OGN-SMD and OGN product family combined.

Product Change Notification					PCN OGN family consolidation		
owner	creation date	release date	released by	change order no	rev	page	D10-063-657
sariogar	03.03.2022	14.04.2022	schulejo	2023609	A	1 of 4

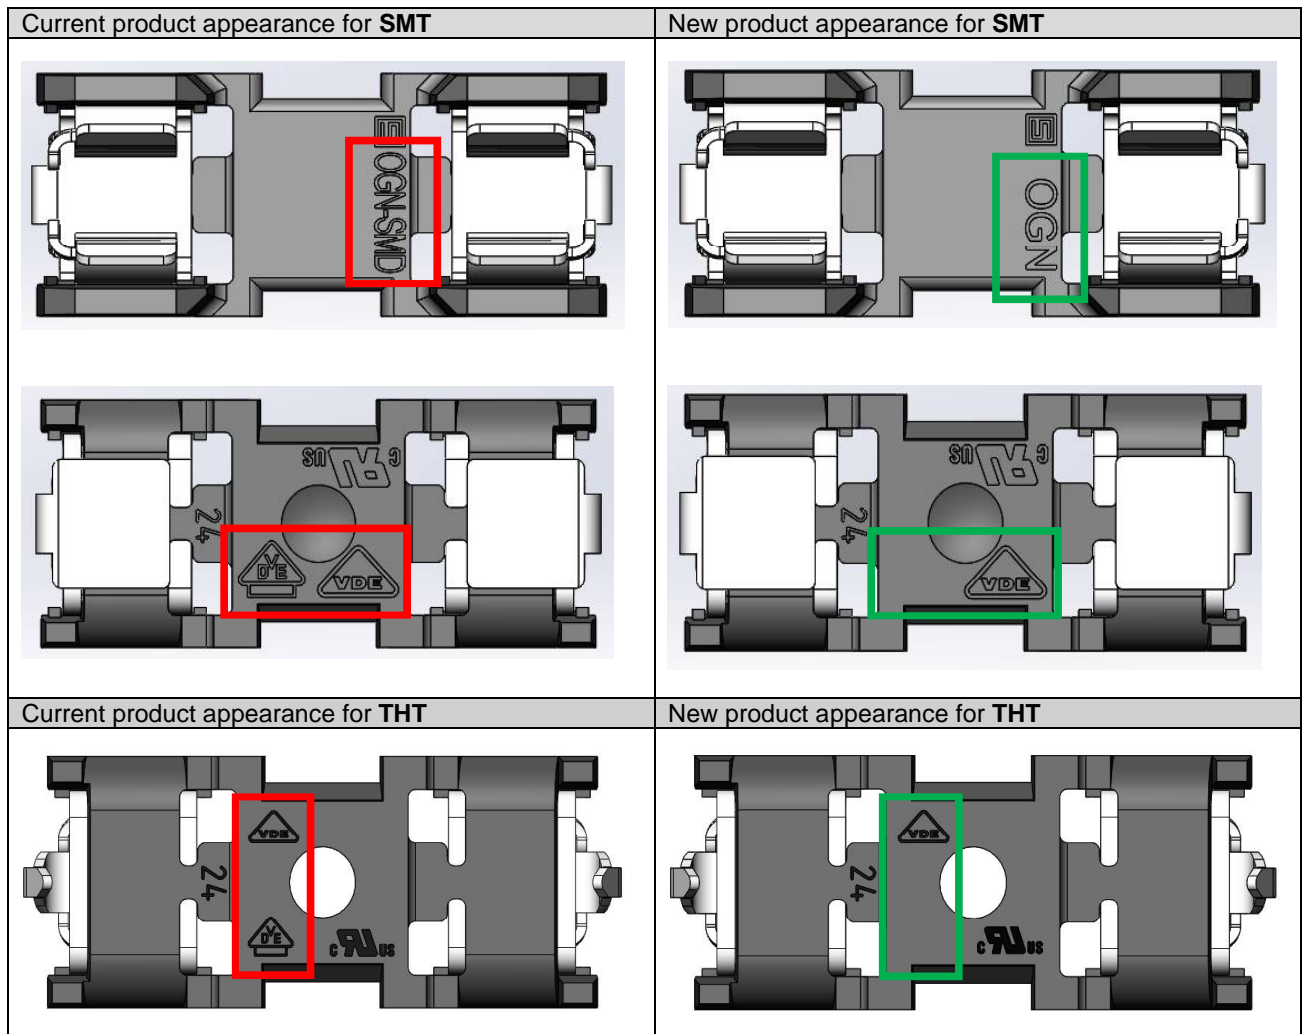
Current label for SMT	New label for SMT
Current label for THT	New label for THT
Current product rating	New product rating
UL 500V / 16A VDE 250 VAC / 4W / 10A VDE ÜG 500 VAC / 4W / 16A	UL 500V / 16A VDE 250 VAC / 4W / 10A VDE 500 VAC / 4W / 16A
Current configuration code	New configuration code
OGN-140-11-0 OGNSMD-250-11-0	OGN-140-11-0 (OGN for THT) OGN-250-11-0 (OGN for SMT)  All standard OGN-SMD parts will have the configuration code changed by removing "SMD". The first number of the configuration code indicates the mounting method.

- Form                                      No action required, no change of dimensions
- Fit
- Function
- Manufacturing
- Label                                      Verify your approval documents to use VDE ÜG file number 40045404
- Packaging
